TECHNICAL SERVICE BULLETIN

2.7L/3.0L EcoBoost - Oil Pan Leaking - Built On Or Before 15-Aug-2019

19-2387
19 December 2019

E309539

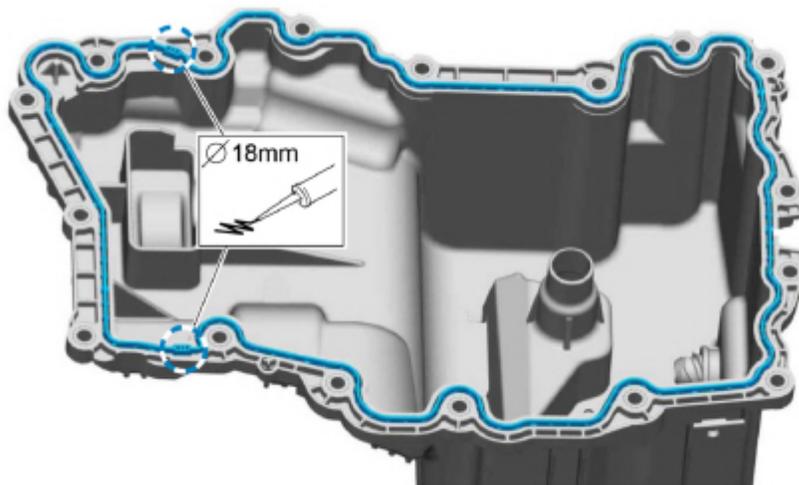
1. Remove and discard the oil pan and oil pump seal. Refer to Workshop Manual (WSM), Section 303-01.
2. Clean and prepare the engine sealing surface. Refer to WSM, Section 303-00.
3. Install the new oil pump seal.
4. Apply a 18 mm (0.708 in.) bead of Motorcraft® High Performance Engine RTV Silicone to engine the front cover-to-cylinder block joint areas on the oil pan. (Figure 1)

NOTE: The new oil pan does not require the use of Motorcraft® High Performance Engine RTV Silicone in any other location.
